Field Change Requests

FIELD CHANGE REQUEST NO.: LEIDOS_FWGW_001

PROJECT: Groundwater Investigation and Reporting Services, RVAAP Restoration Program

BRIEF DESCRIPTION: Monitoring Well Total Depth Collection

Figure 1. Sand Creek Monitoring Well Locations

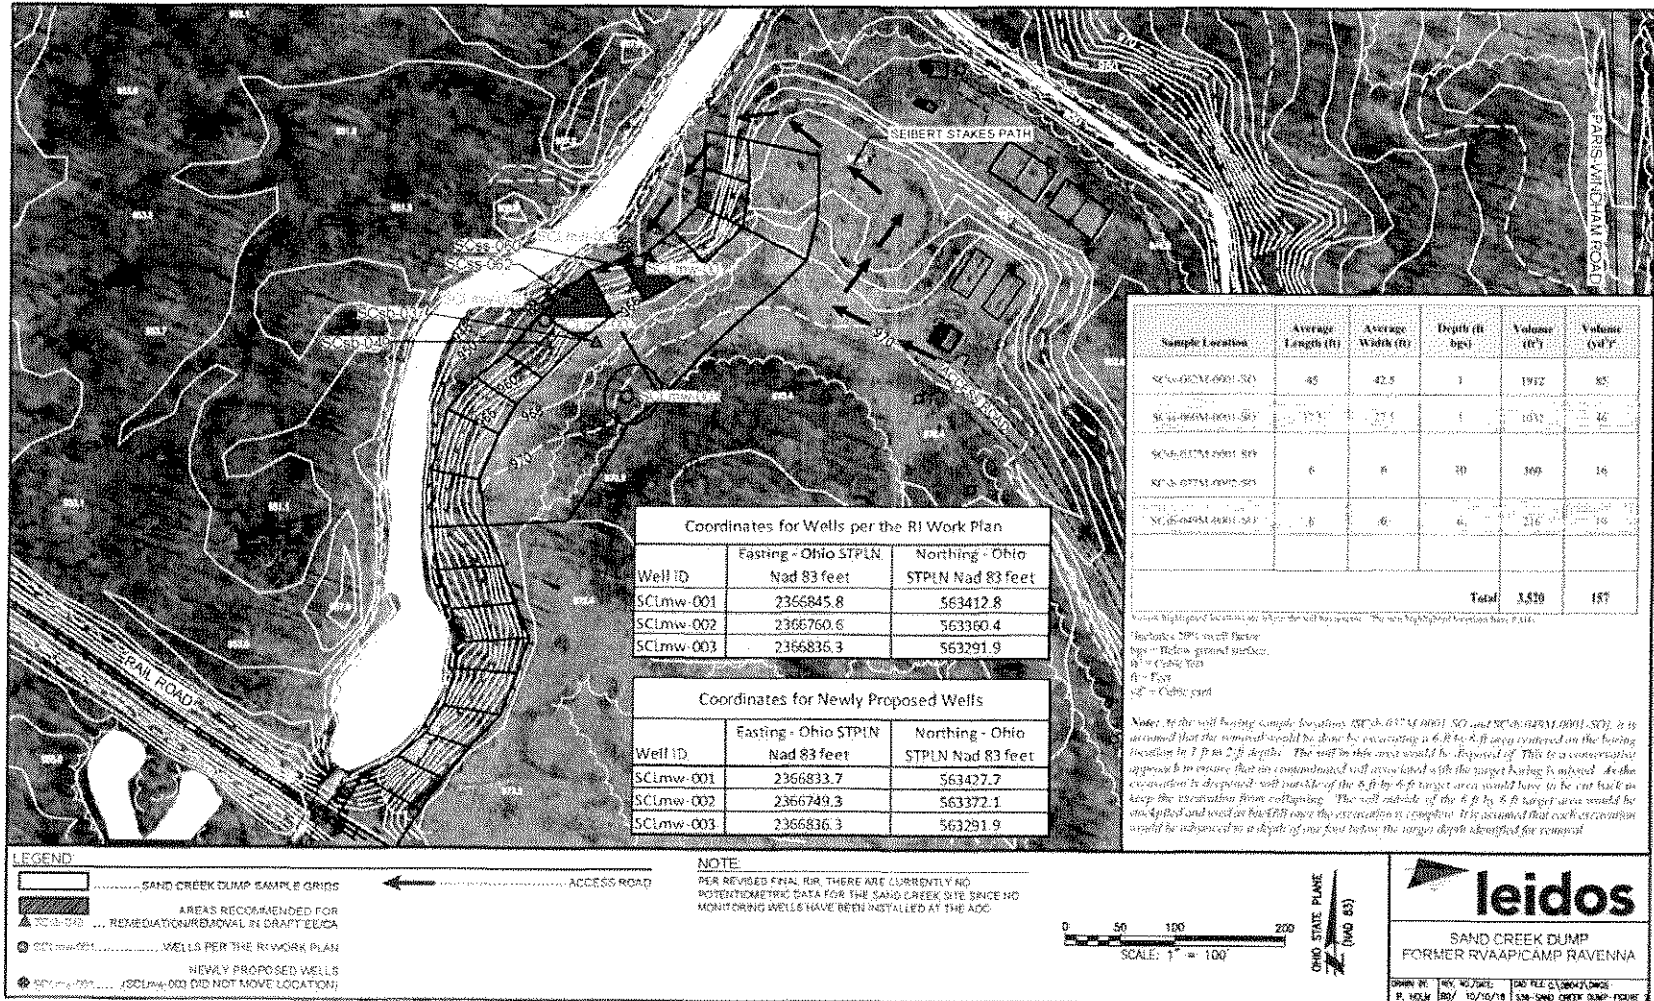
BRIEF DESCRIPTION: Sand Creek Well Locations

REQUESTOR IDENTIFICATION	
NAME/TITLE: Jed Thomas, Deputy Project Manager PHONE: 330-405-5802	ORGANIZATION: Leidos
	10/10/18
SIGNATURE	DATE
BASELINE IDENTIFICATION	
BASELINE(S) AFFECTED <input type="checkbox"/> Cost <input type="checkbox"/> Scope <input type="checkbox"/> Milestone <input checked="" type="checkbox"/> Method of Accomplishment	
AFFECTED DOCUMENT (TITLE, NUMBER AND SECTION): Final Remedial Investigation Work Plan for Groundwater and Environmental Investigation Services for RVAAP-66 Facility-wide Groundwater (RI Work Plan)	
DESCRIPTION OF CHANGE: Within the RI Work Plan (Table 1-3), a data gap was identified at RVAAP-34 Sand Creek Disposal Road Landfill. The following is the description provided in the data gap analysis: "Unconsolidated Aquifer. Sample groundwater for the presence of explosives, SVOC and VOC constituents leaching from soil to groundwater above current screening levels." Accordingly, the RI Work Plan provided locations for new permanent monitoring wells to be installed at the site. These locations are presented on figure C-9 of the RI Work Plan. These permanent wells will be sampled for a minimum of four quarters, and the collected groundwater will be analyzed for the "RVAAP full suite". However, the locations of two monitoring wells (SCLmw-001 and SCLmw-002) are in an area that the Army is proposed to conduct a Non-Time-Critical Removal Action (NTCRA). Figure 1 of this FCR depicts the proposed locations of the wells per the RI Work Plan, and the areas anticipated to undergo removal or remediation per the NTCRA. To ensure placement of these permanent monitoring wells (SCLmw-001 and SCLmw-002) is far enough from the future NTCRA, the Army would like to move the locations of the wells to between the AOC boundary and Sand Creek. The newly proposed well locations are presented on Figure 1. In addition, due to the sloped access to these well locations (i.e., difficulty to safely get equipment to the site) and proximity to Sand Creek, the drilling subcontractor will install the wells and bollards by hand auguring or use of a gas-powered hand operated auger machine. A HSA drill rig will be able to safely traverse the slopes to access the locations. In addition, water from Sand Creek may be used to mix concrete during the well installation process to help eliminate the manual transport of water as a health and safety precaution.

JUSTIFICATION: The location of the permanent monitoring wells per the RI Work Plan is currently within the area the Army anticipates conducting a NTCRA. Moving these wells will help avoid well disturbance during the removal action.
